Yarra Planning Scheme Amendment C191yara

Comparison of the exhibited version of the amendment documents, excluding maps that are addressed separately in Attachment 8, and the version of the amendment documents for adoption, and the reasons for the changes.

Schedule 17 to the Design and Development Overlay (DDO17)

Plan 2: Access and Movement Plan – Precinct 3 Swan Street East

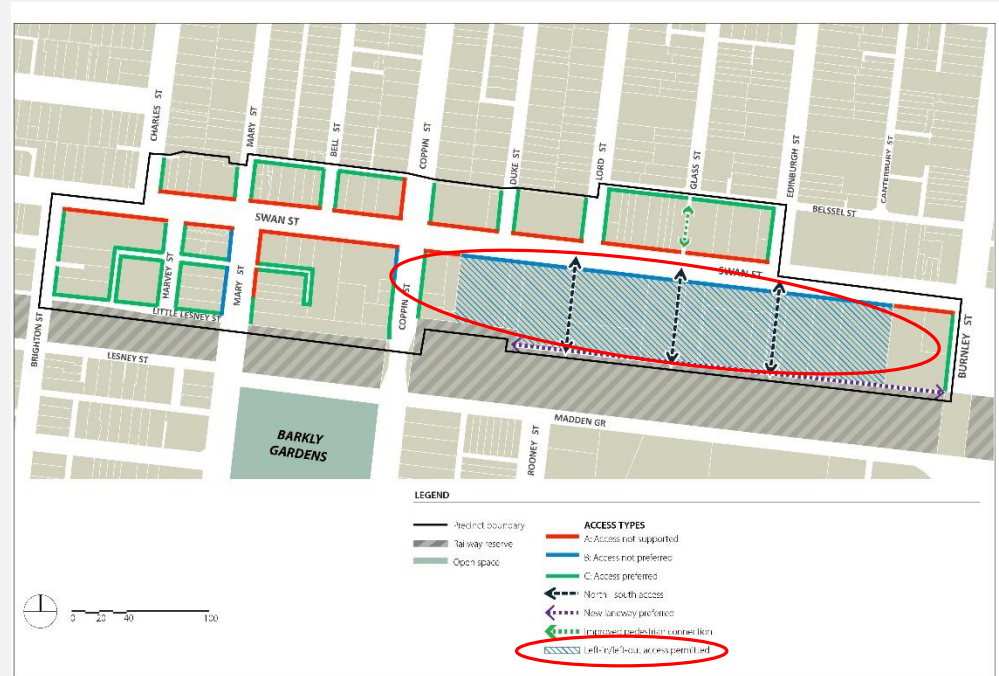
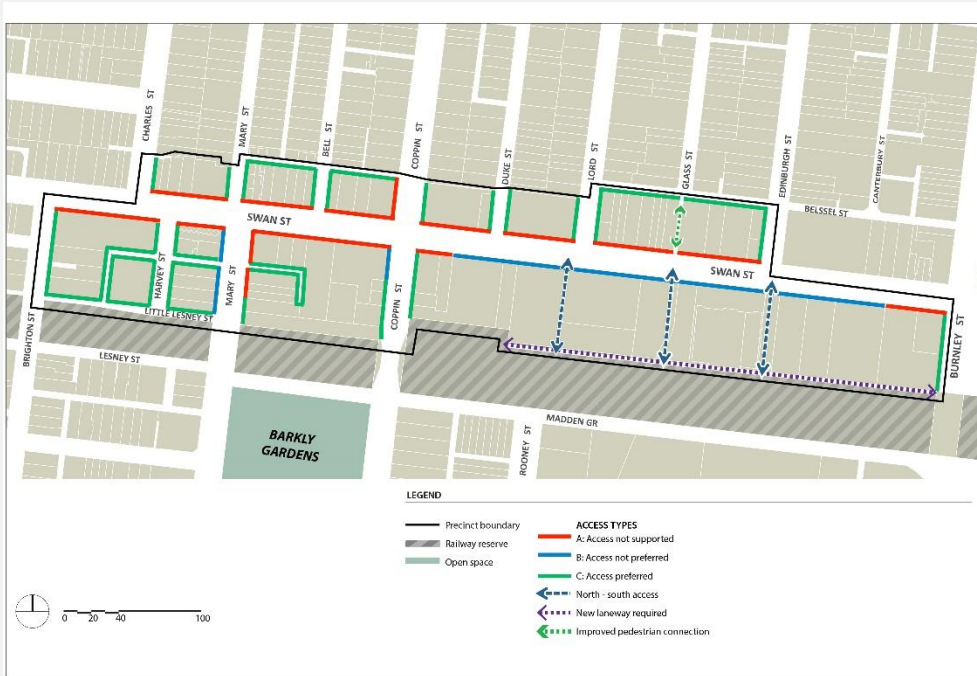
86.	Plan 2: Access and Movement Plan – Precinct 3 Swan Street East	<u>No land identified as “Left in – Left Out Access Permitted”</u> 348-442 Swan Street	<u>Land identified as “Left in – Left Out Access Permitted”</u> 348-442 Swan Street	Council's traffic expert witness (Ms Dunstan's evidence in chief) recommended that turning movements in and out of the north-south access ways in Precinct 3 and any other vehicle entrances in this section of Swan Street should be limited to 'left in-left out' only.

ROW NO.	REQUIREMENT	DDO17 EXHIBITED METRICS (* DENOTES MANDATORY)	DDO27 FOR ADOPTION METRICS (* DENOTES MANDATORY)	REASON FOR CHANGE
				<p>The 'Plan 2 Access and Movement Plan – Precinct 3 Swan Street East' in DDO27 has been changed to facilitate left in-left out access.</p> <p>This change was supported by the Panel.</p>

Plan 1: Height and Interface Plan – Precinct 4 Burnley Station

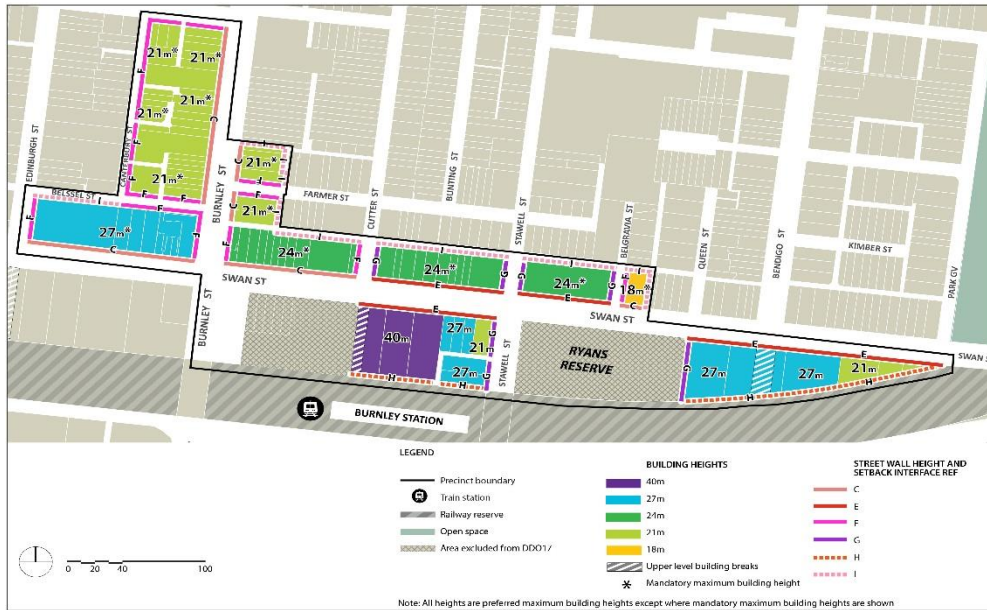
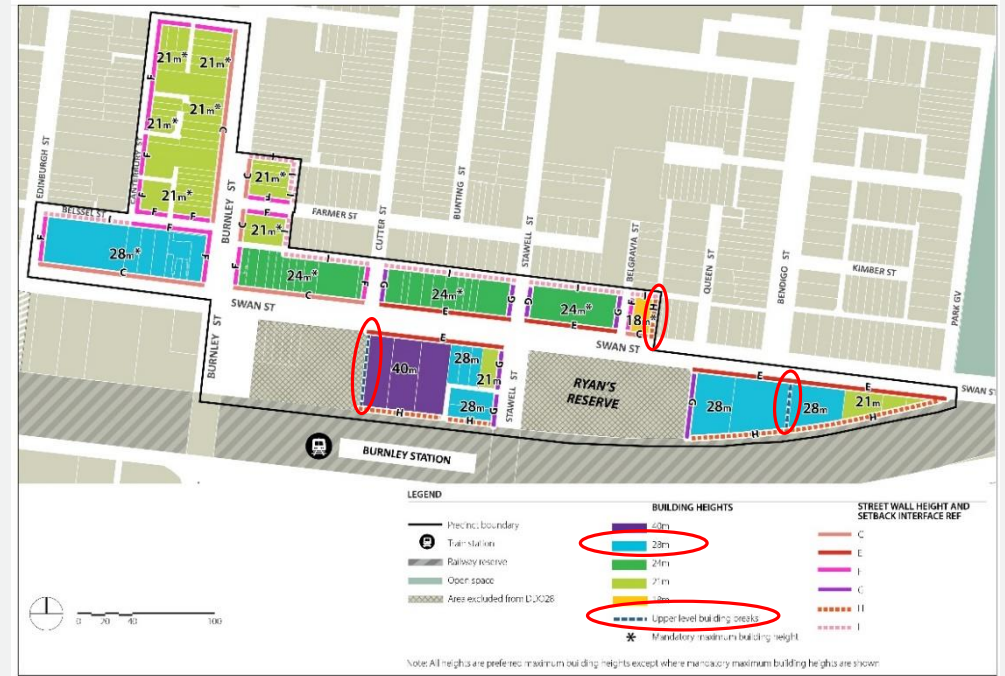
96.	Upper level setback	<u>Interface I</u> <i>Eastern title boundary of 487 Swan Street</i> <ul style="list-style-type: none"> Development must be setback in accordance with Figure 1 and 2. Development must minimise repetitive stepped form. 	<u>Interface H</u> <i>Eastern title boundary of 487 Swan Street</i> <ul style="list-style-type: none"> 0m minimum unless setback is identified on Plan 2. 	<p>The exhibited DDO17 specifies an 18m mandatory maximum building height for 487 Swan Street. The eastern interface of the site has 'Interface I' (Residential Interface) in DDO17, however, the land to the east is in the Commercial 1 Zone. As such, the DDO28 for adoption applies 'Interface H' (rather than Interface I) to the eastern title boundary, to reflect the non-residential interface.</p> <p>This change was supported by the Panel.</p>

Plan 2: Access and Movement Plan – Precinct 4 Burnley Station

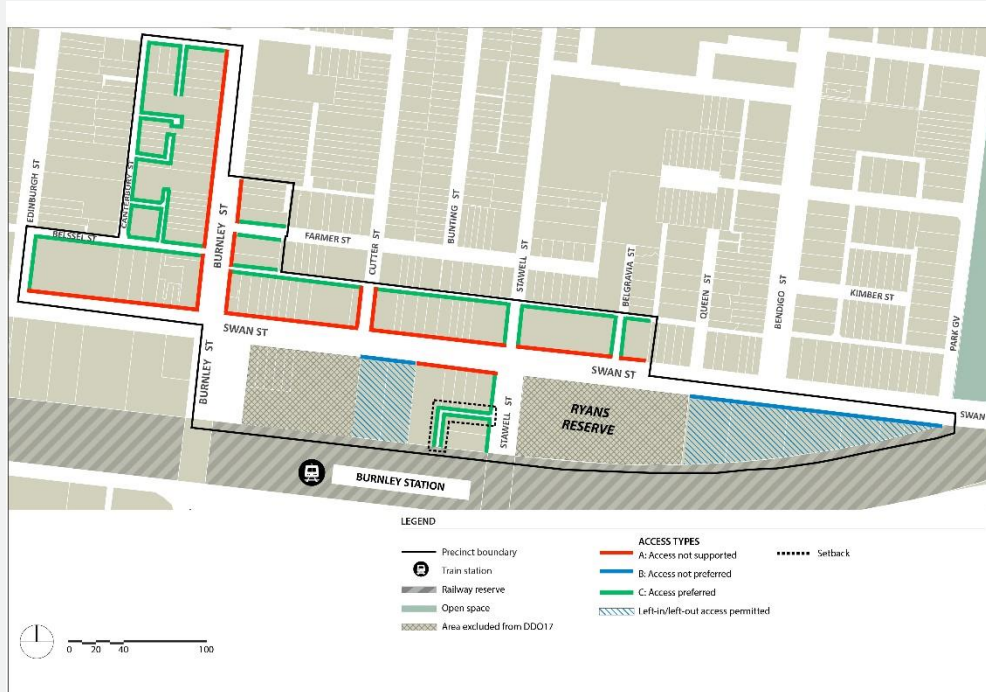
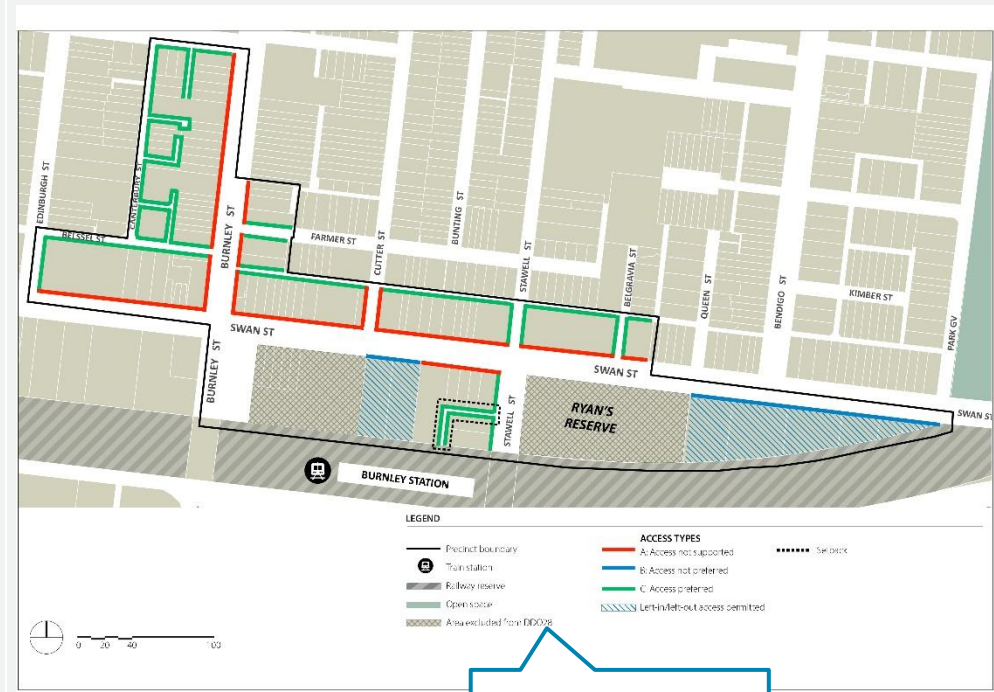
The word 'DDO17' replaced with 'DDO28'.

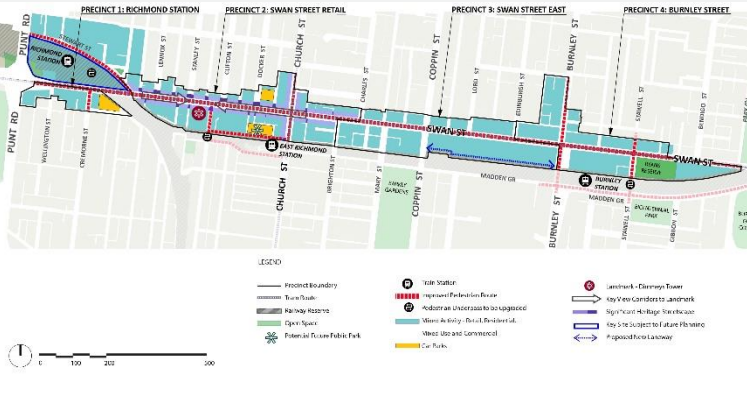
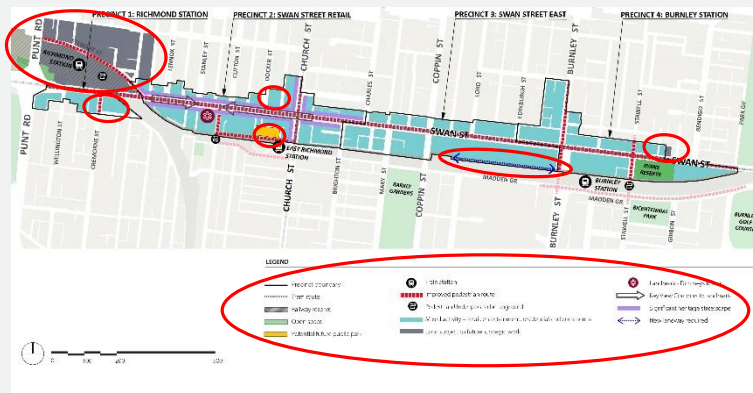
ROW NO.	EXHIBITED CLAUSE 21.11 REFERENCE DOCUMENTS	CLAUSE 21.11 REFERENCE DOCUMENTS FOR ADOPTION	REASON FOR CHANGE
			<ul style="list-style-type: none"> The Swan Street Framework in its current 2017 form no longer accurately reflects the proposed provisions sought to be introduced through the considerably refined version of the Amendment. The DDOs for adoption have departed from the exhibited version of DDO17 (for the reasons set out above) which reflected a more faithful translation of the Swan Street Framework.
